MFN No. 050-89

Docket No. STN 50-605

Subject: **Submittal of Responses to Additional Information as Requested
in NRC Letter from Dino C. Scaletti, Dated May 16, 1989**

Enclosed are thirty four (34) copies of the Responses to Request for Additional Information (RAI) on the Standard Safety Analysis Report (SSAR) for the Advanced Boiling Water Reactor (ABWR). These responses principally pertain to Chapters 7 and 8.

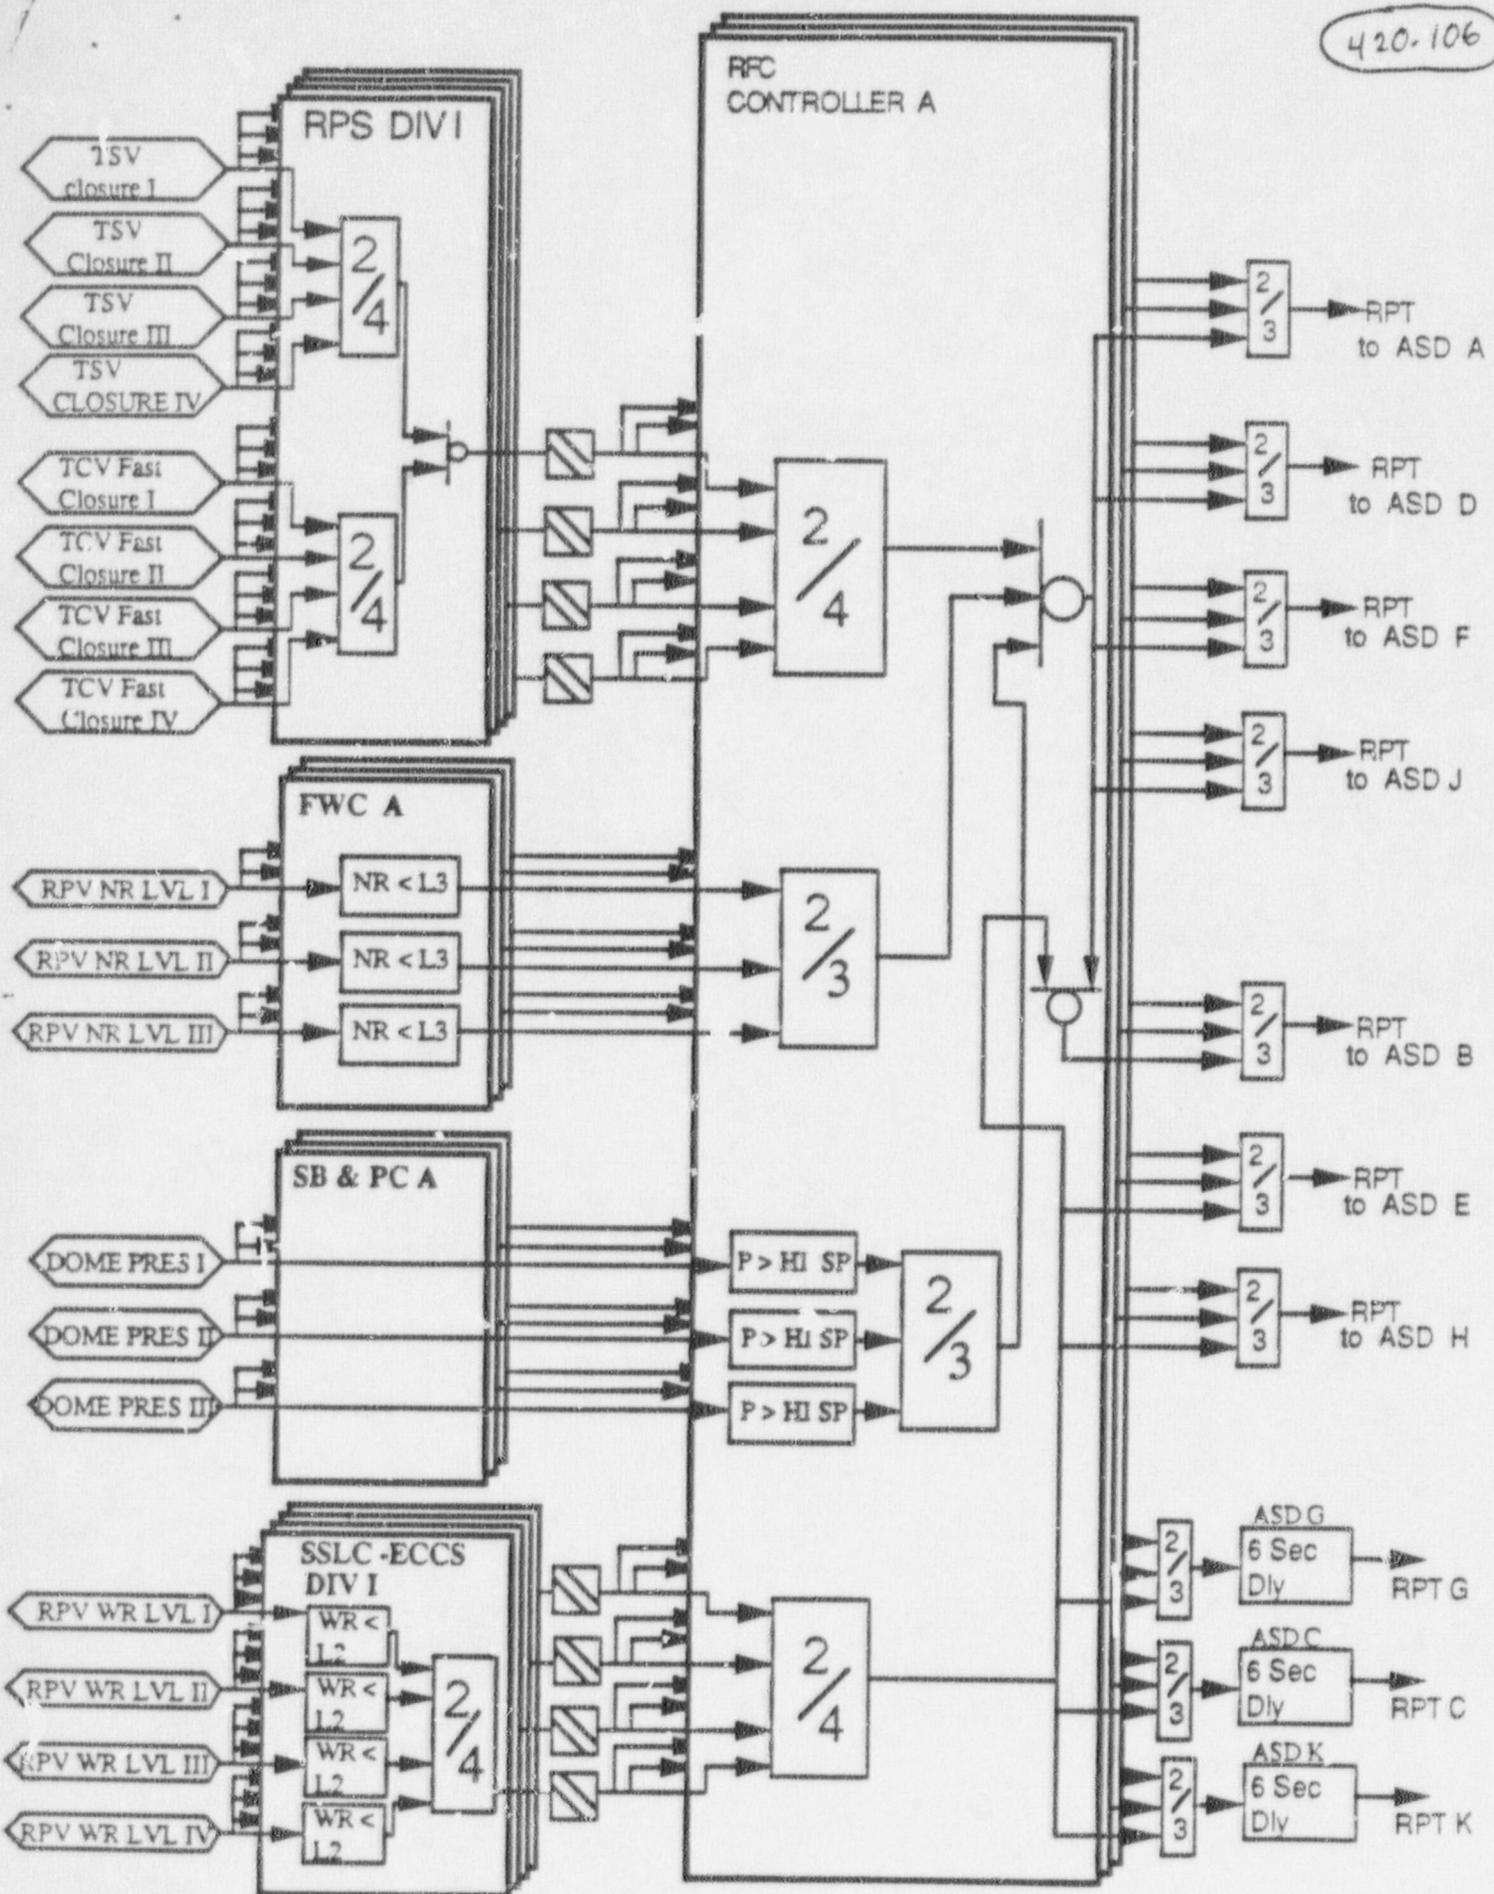
420.033 (7.1.2.3.2) Add to 7.1.2.3.2(2)(c)... "without causing plant shutdowns" or reducing safety margins.

420.033 The addition to the text has been added as shown in attached mark-up of this section.

^{LDS}
The ~~LD&IS~~ instrumentation and control is designed to:

- (a) provide sufficient redundancy of instruments to avoid unnecessary plant shutdowns due to instrument malfunctions;
- (b) avoid plant shutdowns due to a single power supply failure; and
- (c) provide the capability to maintain, calibrate, or adjust system monitors while operating without causing plant shutdowns for reducing safety margins.
- (d) provide status information to annunciator and process computers.
